TRANSPORT TECHNICAL NOTE 2 (TN2)

T25512

LAND EAST OF WROTHAM ROAD

7th September 2026

PROJECT NO. T25512	DRAWING NO. 001	REV H
-----------------------	--------------------	----------

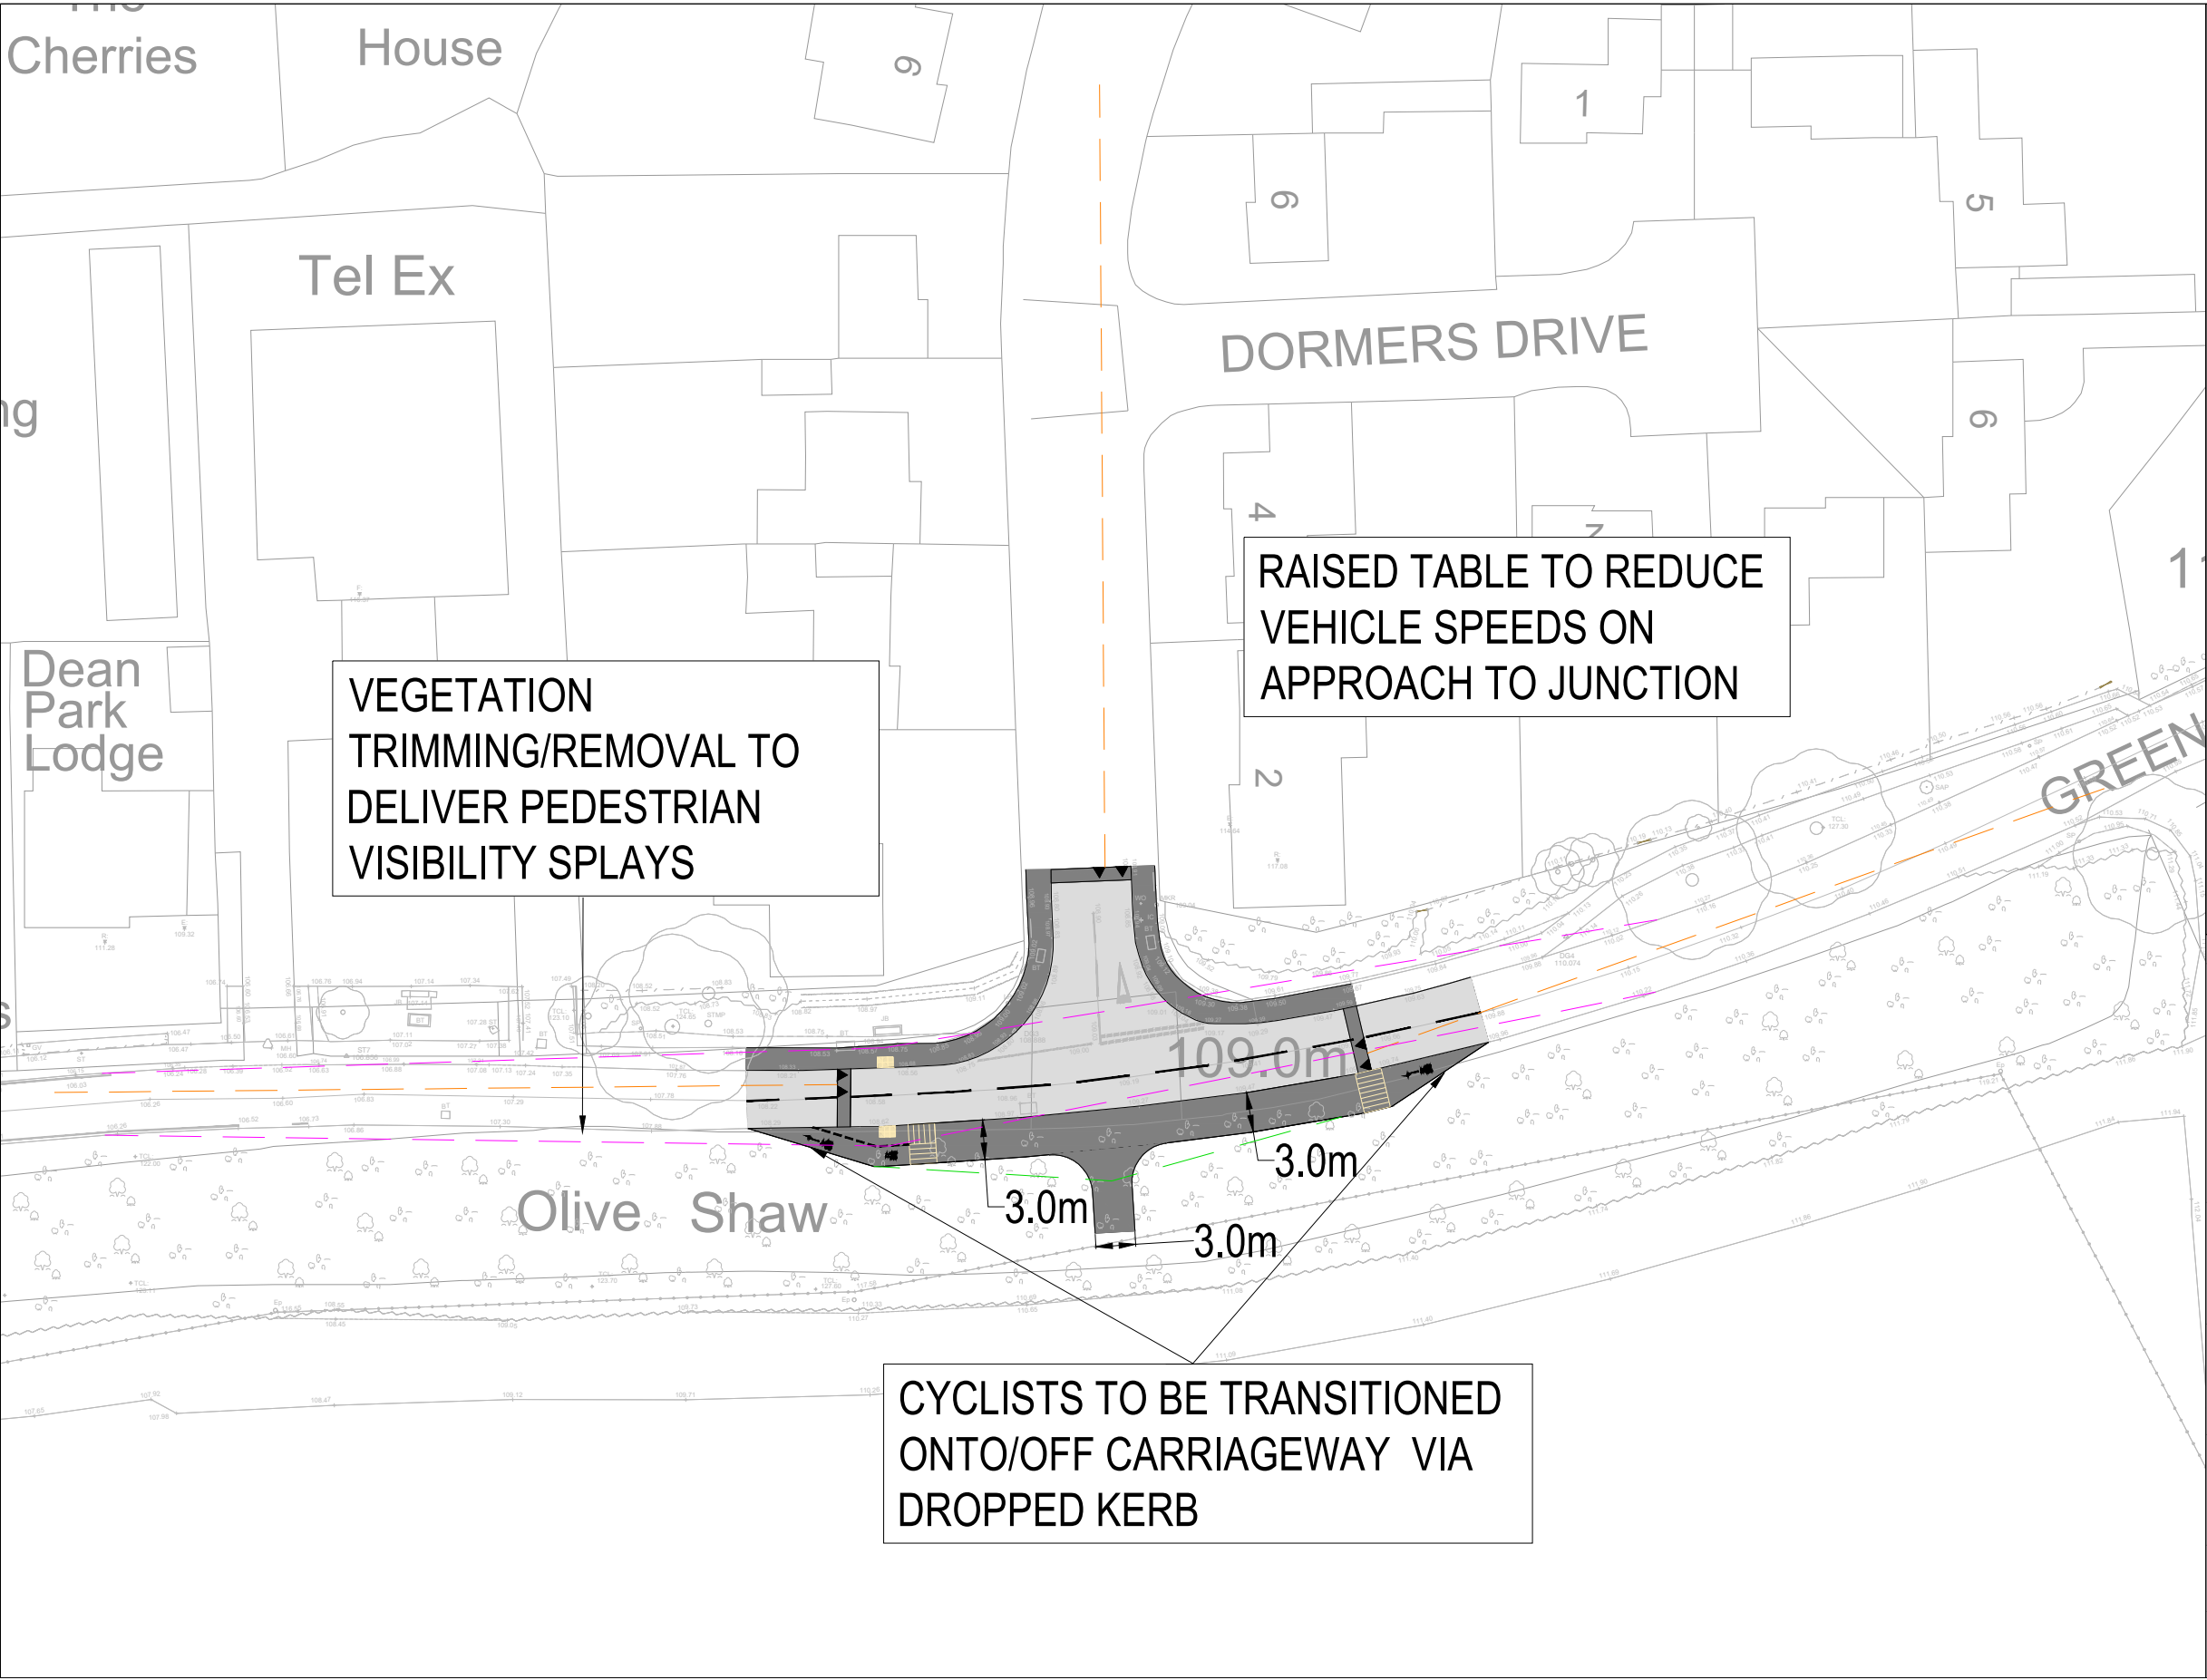
VISIBILITY SPLAYS	
Visibility splays are shown on the 'Proposed Site Access with Visibility Splays 01' plan, Ref T25512 001 Rev G, 'Proposed Site Access with Visibility Splays 02' plan, Ref T25512 001.01 and 'Pedestrian / Cyclist Visibility Splays at Crossing Points' plan Ref T25512 005. However, some of the splays are shown incorrectly. For example, the site access x splay should be shown 2.4m back from the first give way line (east of the continuous crossing) as this is the position of waiting vehicles before they emerge onto the A227. Some of the splays are shown to terminate within the	Comment accepted. The x distance for the visibility splay for the site access has been taken at a setback distance of 2.4m from the eastern give-way line as requested. We have reciprocated this for the emergency access. We are unsure which splays are taken to the middle of the footway KCC are referring to; however, this could be in reference to visibility splays provided from the active travel access points onto the proposed shared route. For clarity, the following visibility splays have been shown.

A 59m splay is shown for the south to north crossing of Green Lane at the A227 / Green Lane junction. The vegetation within this splay must be cut back (without removing highway trees) to ensure it is achieved. Given how quickly vegetation can grow and obscure the visibility, it is suggested that the crossing is moved closer towards the A227. Whilst this slightly lengthens the crossing time, it would retain pedestrians closer to the desire line whilst maximising visibility.	Comment accepted. The vegetation will be cut back to ensure visibility can be maintained for pedestrians crossing the A227/Green Lane junction. We can confirm that no trees within the highway extent are required to be removed. The highway boundary extent included at Appendix F. Following review and to minimise as much vegetation loss as possible, a 33m visibility splay to the east has been shown in accordance with a 25mph speed limit based on MfS. This is considered to be reasonable given vehicles will be reducing their speed at this point on approach to the junction. The crossing point has also been moved closer towards the A227 and is shown in Drawing T25512.001 Rev H. Please note this is the furthest it can be moved before the pedestrian visibility from the northern footway crosses third party land to the east.

The applicant has also requested KCC consideration of a priority crossing at this junction; however, KCC does not consider this to be appropriate.	Comment accepted. A priority crossing will not be proposed.
The forward visibility to the raised table at the Green Lane / Trandescant Drive junction should be shown, to confirm it is achievable. The splays requested by KCC are likely to be achievable but need to be shown so they can be conditioned.	Comment accepted. Forward visibility splays to the raised table at the Green Lane/Trandescant Drive junction have been included on Drawing T25512.001 Rev H.

footway, but these can be taken to the edge of the nearside carriageway, which should offset the revised x distance.	• Site Access and Emergency Access Visibility Splays at a 2.4m setback from the continuous footway/cycleway. • Pedestrian/Cycle visibility splays at crossing locations at a 1.5m setback from the kerb. • Pedestrian/Cycle visibility splays emerging from the active travel access points at a 2.4m setback. This represents a robust assumption of cyclists that may not stop on approach to the shared facility. 18m splays are provided in accordance with Manual for Streets (MfS) to represent a cycling speed of 16mph which again is robust. • Forward visibility splays based on the recorded speed on Wrotham Road and of the sign posted speed limit on Green Lane. For ease of presentation, we have amended the relevant drawings by delineating the different visibility splays (i.e. vehicle visibility, pedestrian/cyclist visibility, forward visibility). These are included in Drawings T25512.001 Rev H, T25512.001.01 Rev B and T25512.005 Rev A.

PEDESTRIAN/CYCLIST VISIBILITY SPLAYS AT CROSSING POINTS

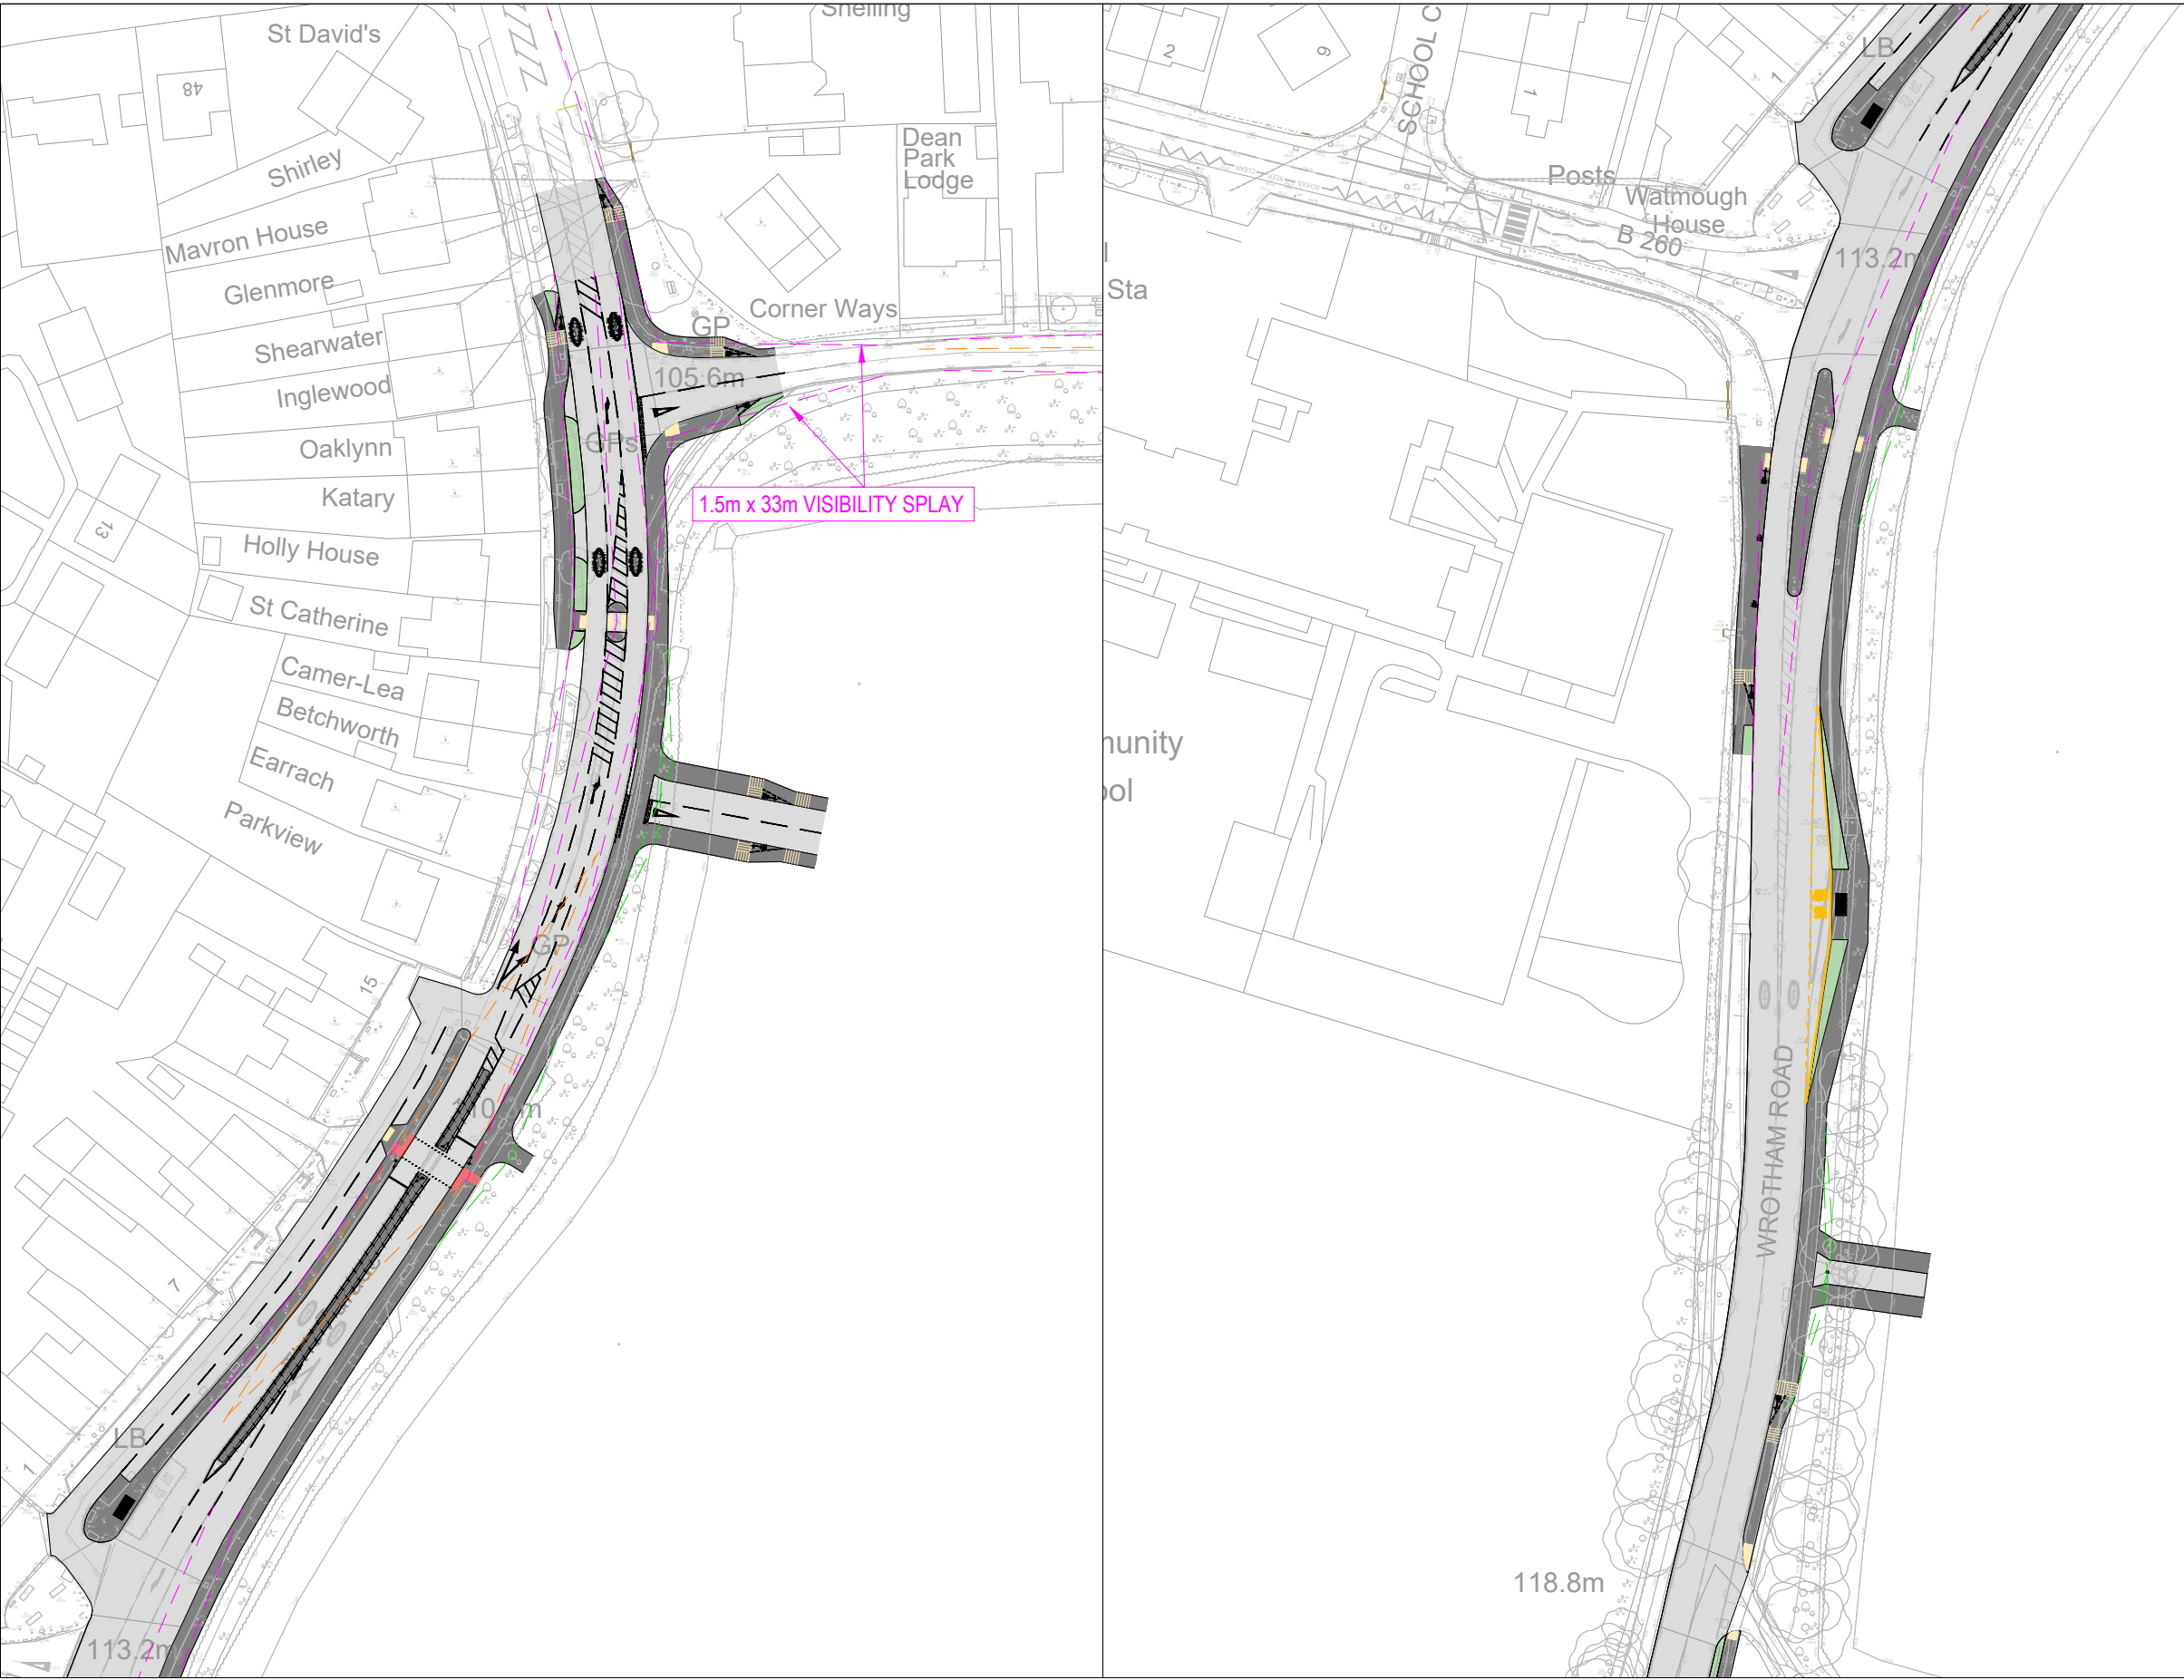
Visibility splays are shown on the 'Proposed Site Access with Visibility Splays 01' plan, Ref T25512 001 Rev G, 'Proposed Site Access with Visibility Splays 02' plan, Ref T25512 001.01 and 'Pedestrian / Cyclist Visibility Splays at Crossing Points' plan Ref T25512 005. However, some of the splays are shown incorrectly. For example, the site access x splay should be shown 2.4m back from the first give way line (east of the continuous crossing) as this is the position of waiting vehicles before they emerge onto the A227. Some of the splays are shown to terminate within the footway, but these can be taken to the edge of the nearside carriageway, which should offset the revised x distance.
